Proposal
to introduce requirements for the approval
of replacement brake discs for L-category vehicles
in UN Regulation No. 90

79° GRRF
16 February 2015

At the 78° session of GRRF held on 16 Sept 2014, ITALY had tabled a proposal (doc [ECE/TRANS/WP.29/GRRF/2014/23](#))

Back up slides – top hat parallelism

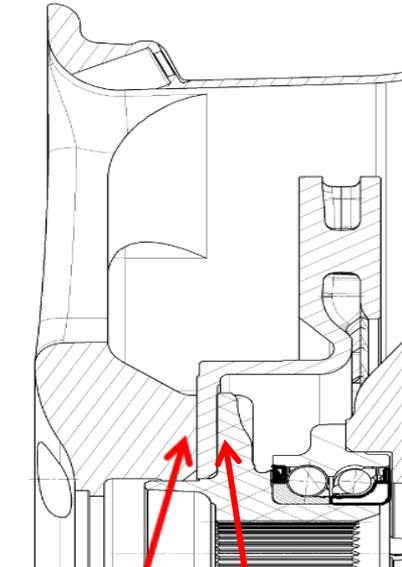
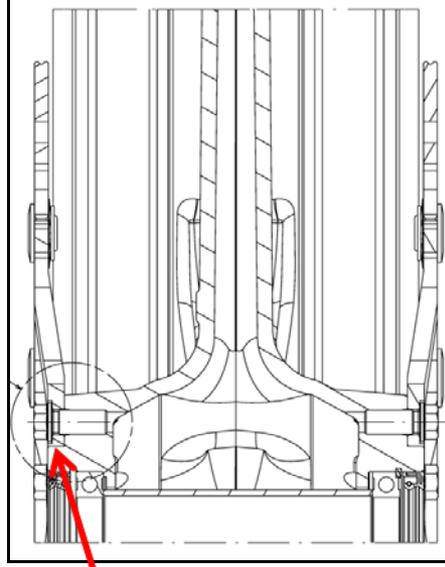
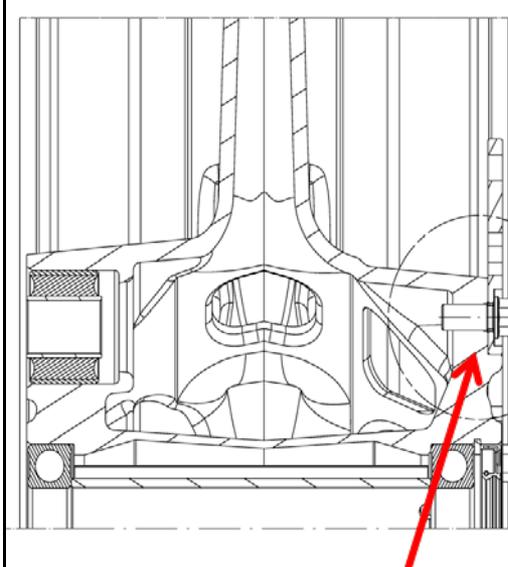
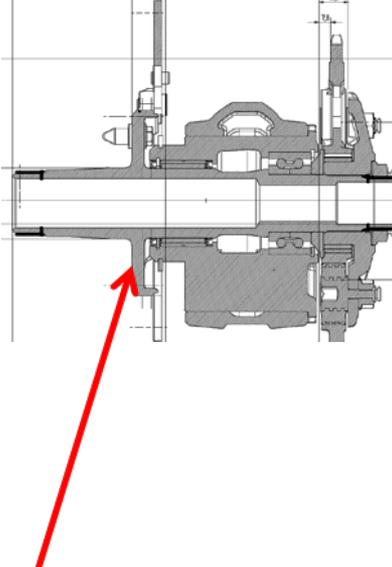
Why no values for L ??

Not applicable to L, since the disk is always mounted externally on the wheel rim, and not interposed between the wheel hub and the rim

Back up slides – peripheral disc

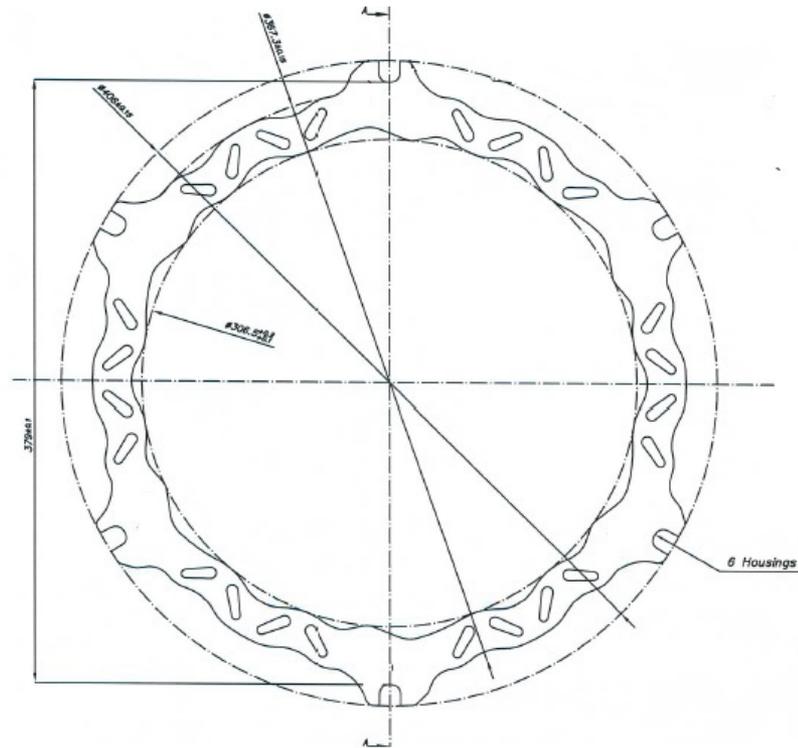
Need to define a better classification, not based on commercial definition

A new classification is proposed, based on disc DIAMETER and THICKNESS

- No groups defined for peripheral discs (> 350)
- Fixed, floating and composed discs have all a diameter < 350 mm
- In current production, max of 330 mm is reached

Back up slides – TUV Fatigue test

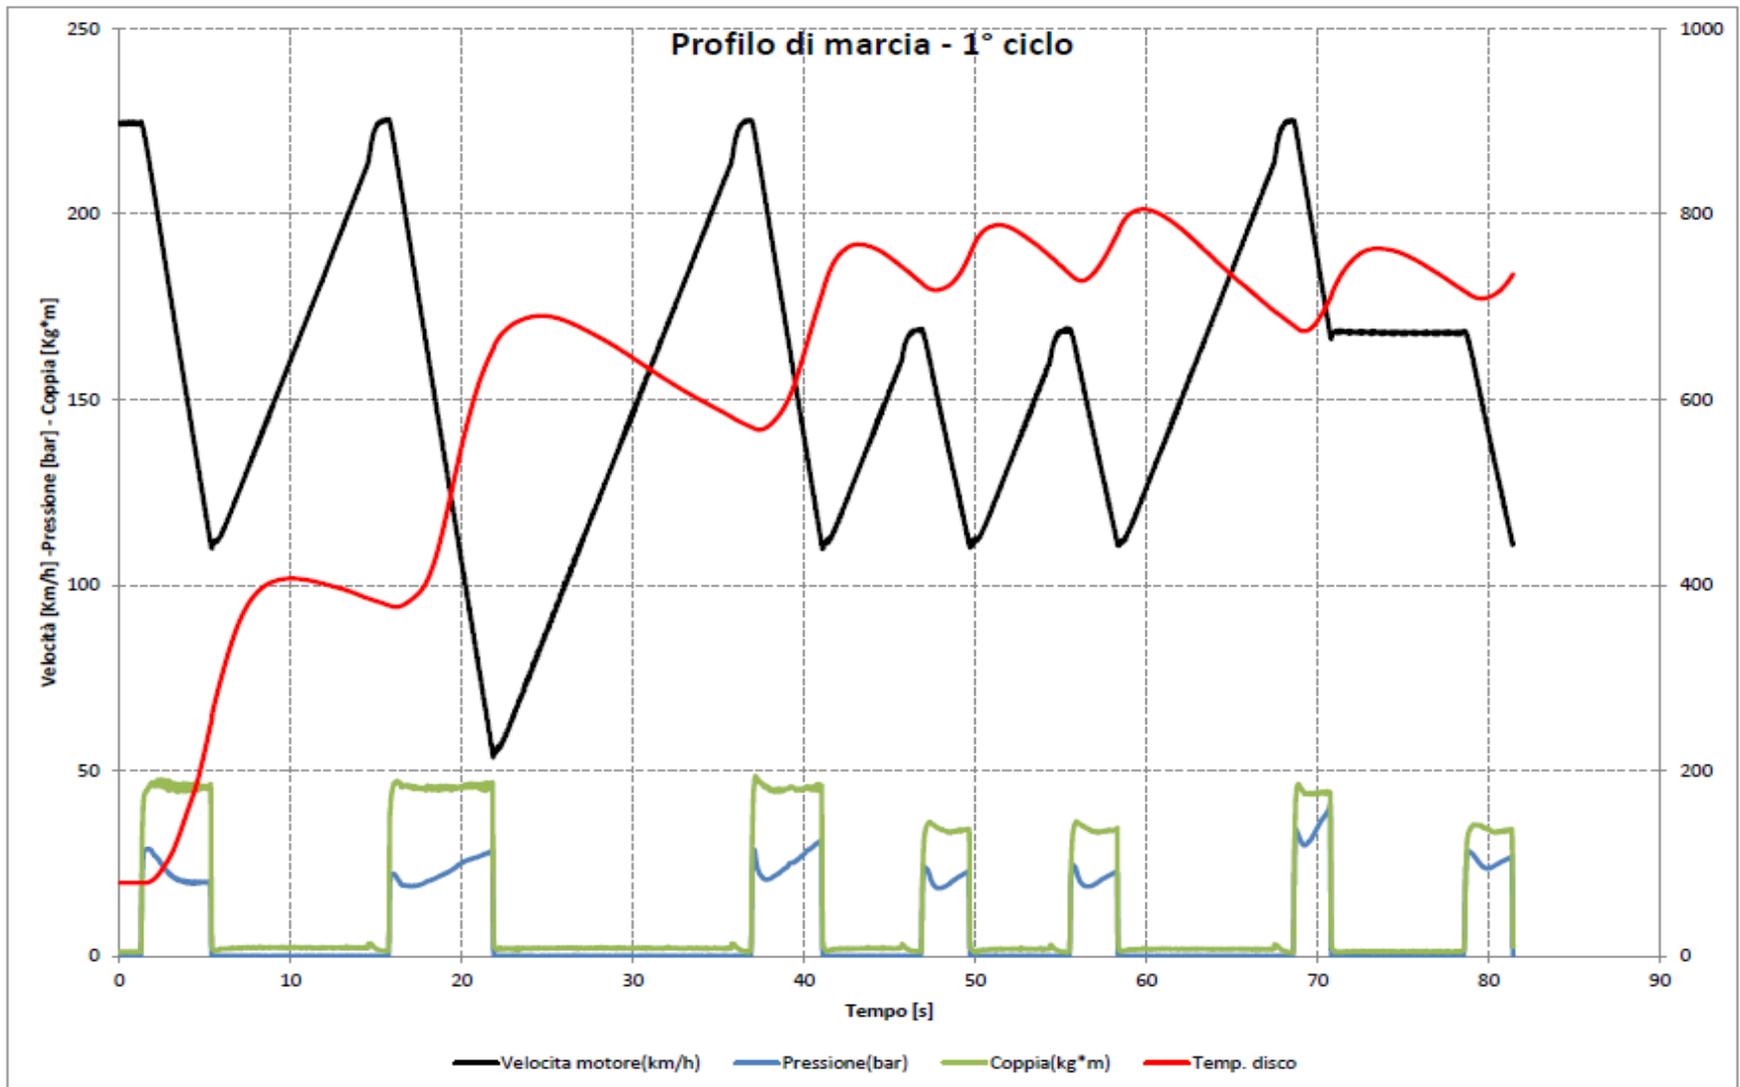
- Emergency stop has been included into fatigue test and improved.
- TUV fatigue test is too severe (at first cycle, T was > 800 °C !!)

The number of cycles have been slightly reduced, BUT the severity of brakins have been also increased.
